## **SERVICE BULLETIN NO. SB-08-071**

<b>SUBJECT:</b>	<b>Hendrickson Tiremaax, Pressure Protection Valve Requirement</b>
-----------------	--

## TIREMAAX™ TIRE INFLATION SYSTEM

**LIT NO:** B115

Figure 1. Pressure protection valve plumbing details

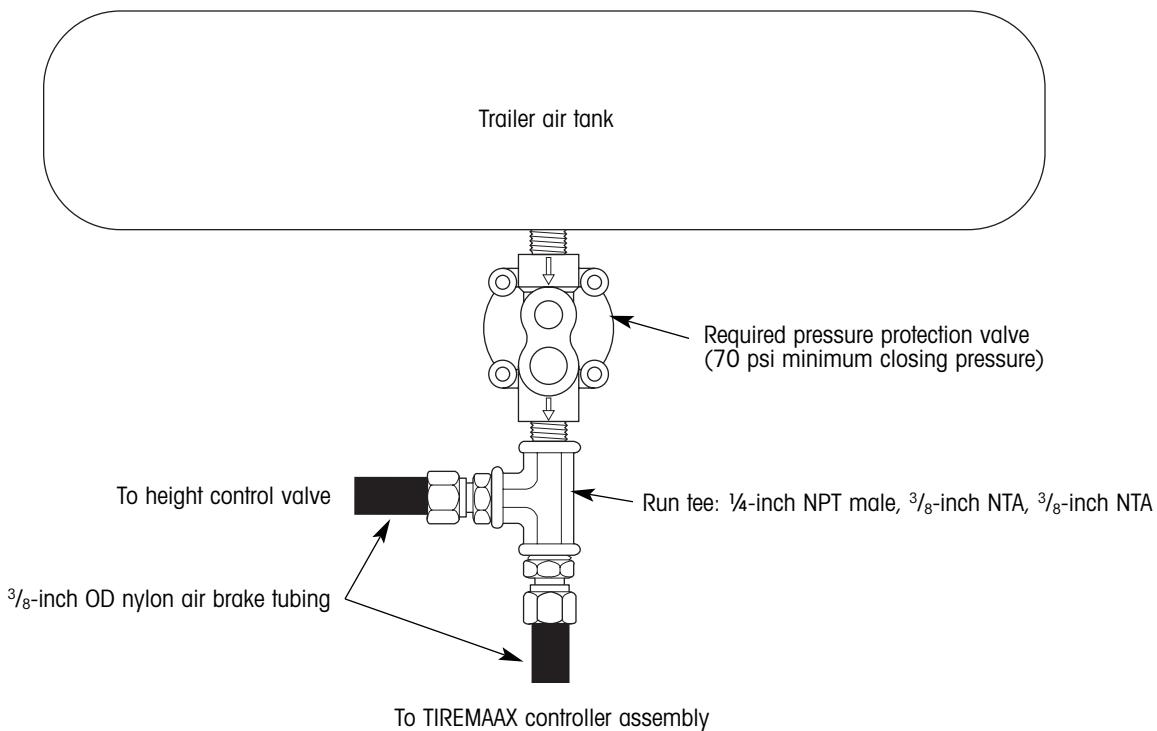
When installing the TIREMAAX™ tire inflation system, a pressure protection valve (PPV) is required between the trailer air tank and the TIREMAAX controller assembly (figure 1). This detail was inadvertently omitted from the plumbing schematics (figures 20 through 22) in Hendrickson publication L818, *TIREMAAX Tire Inflation System Installation, Service and Troubleshooting Procedures*.

The existing suspension PPV can be used, it is not necessary to add a second or dedicated PPV specifically for TIREMAAX. A tee fitting can be used after the PPV to accommodate both the TIREMAAX controller assembly and the height control valve (figure 1).
